HISTORIC PRESERVATION COMMISSION

ALTERATION TO A HISTORIC PROPERTY STAFF REPORT

Site / District(s):	80 Franklin Street	c. 1850 – Blodgett-Gee House
Case:	HPC 2014.098	Lower Franklin Street Local Historic District
Applicant Name:	Walter Jr. Moura, Contractor	
Applicant Address:	97 Winthrop Street, Medford, MA	
Date of Application:	November 24, 2014	
Legal Notice:	Remove chimney	
Staff Recommendation:	Deny Certificate of Appropriateness	
Date of Public Hearing:	December 16, 2014

80 Franklin Street – Assessors Photo

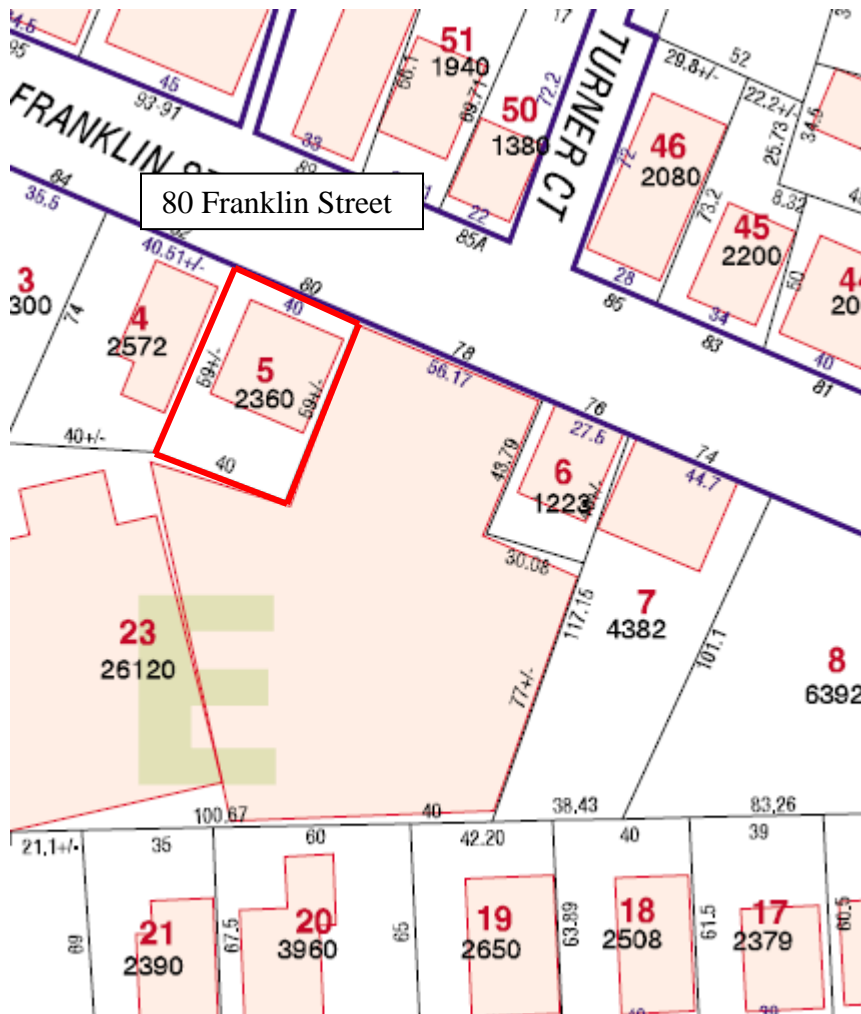
- *What is the visibility of the proposal?* The chimney is visible from the public right of way.
- *What are the Existing Conditions of the building / parcel?* Two chimneys are located behind the ridge line but are clearly visible from Franklin Street. These indicate the locations of rooms and fireplaces or stoves in the rooms below, showing their relative importance as habitable spaces.

The chimney shape form and location will not be preserved.

The proposal does not meet the guidelines as noted above. The chimney would be removed rather than repaired or replaced in kind, and would entail the removal of a character-defining feature. *Existing chimneys are an important architectural detail that in most cases contribute to the architectural integrity of the structure and overall roof form. The chimneys on a historic building form the backbone of its structure; they indicate the building's interior layout and the uses of the rooms inside. Certain chimney styles are associated with particular styles of 18th and 19th century buildings. The style and shape of a chimney, as well as the form of its bricks, may reflect the aspirations of the building's original owners.*

Staff determines that the alteration for which an application for a Historic Certificate has been filed is appropriate for and compatible with the preservation and protection of the Lower Franklin Street Local Historic District; therefore **Staff recommends that the Historic Preservation Commission do not grant Walter Jr. Moura, Contractor for Edson daSilveira, Owner a Certificate of Appropriateness to remove the existing chimney on the south side of the building.**

The Staff recommends that the Applicant be granted a Certificate of Non-Applicability to repair or rebuild the existing chimney with the existing brick or in-kind to match the existing as closely as possible in size, shape, texture and color and with an appropriate mortar that is consistent with the hardness of the bricks used. New flashing should be installed to make the seal with the roof water-tight.
